COMMUNITY BOARD FEEDBACK PACKAGE

DINING OUT NYC

Business Name: Chalong

Cafe Address: 749 9th Avenue, New York, NY, 10019

Sidewalk Cafe Site Plan Form

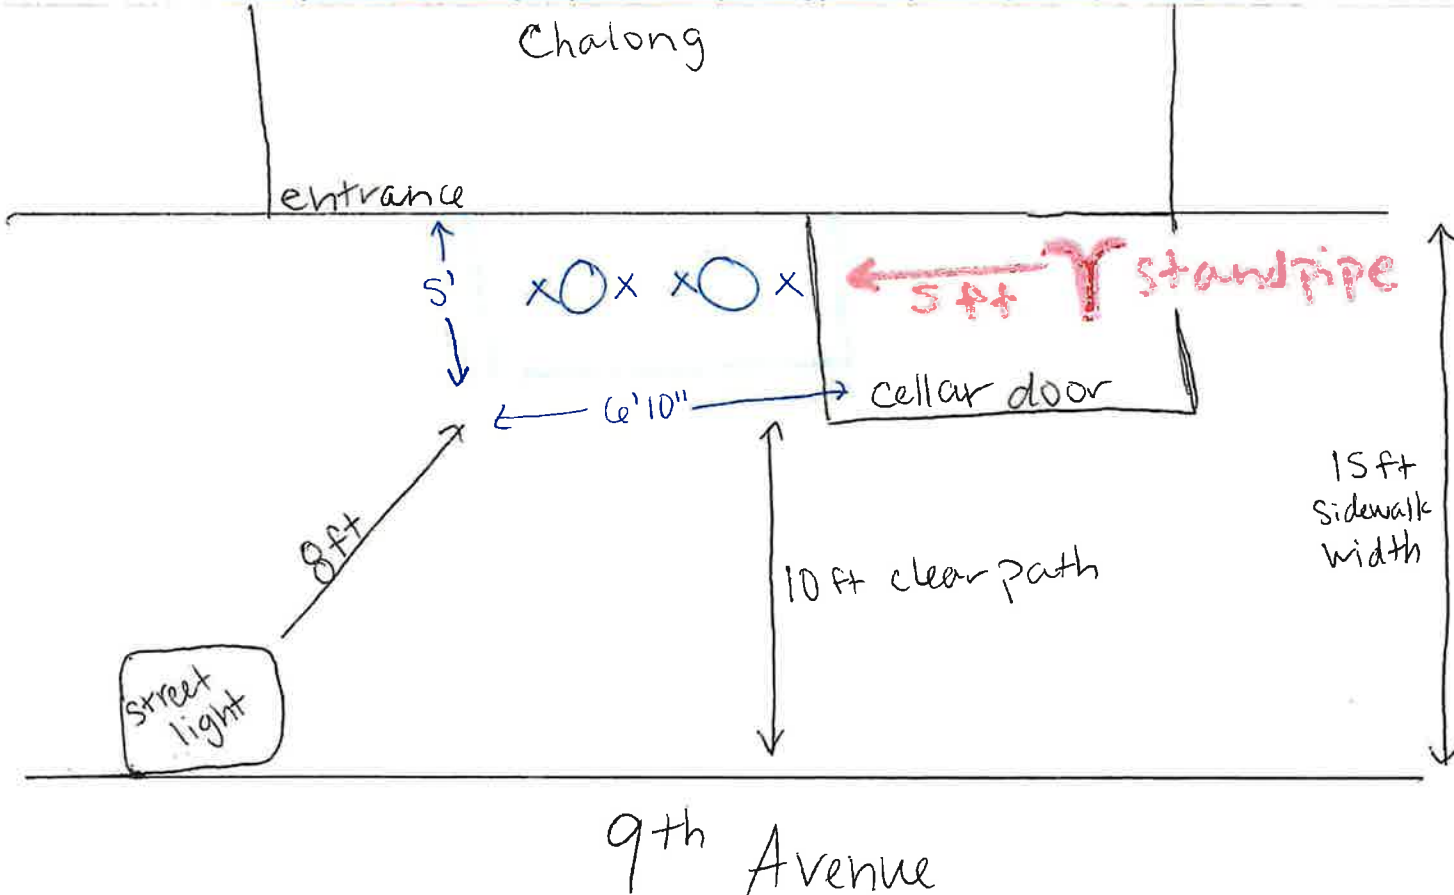
MCB4 has no objection to the footprint of the proposed sidewalk cafe reflected on the Site Plan -- 5' deep by 6'10" wide. We believe, however, that the proposed 2 tables with 2 seats each (plus seated patrons) cannot fit into that footprint and, as a result and in practice, the tables and chairs will likely invade the required 5' clearance from the standpipe located to the right of the cafe. Accordingly, MCB4 proposes that the cafe be limited to one table with either 2 or 4 seats.

MCB4 has no objection to the footprint of the proposed sidewalk cafe reflected on the Site Plan -- 5' deep by 6'10" wide. We believe, however, that the proposed 2 tables with 2 seats each (plus seated patrons) cannot fit into that footprint and, as a result and in practice, the tables and chairs will likely invade the required 5' clearance from the standpipe located to the right of the cafe. Accordingly, MCB4 proposes that the cafe be limited to one table with either 2 or 4 seats.
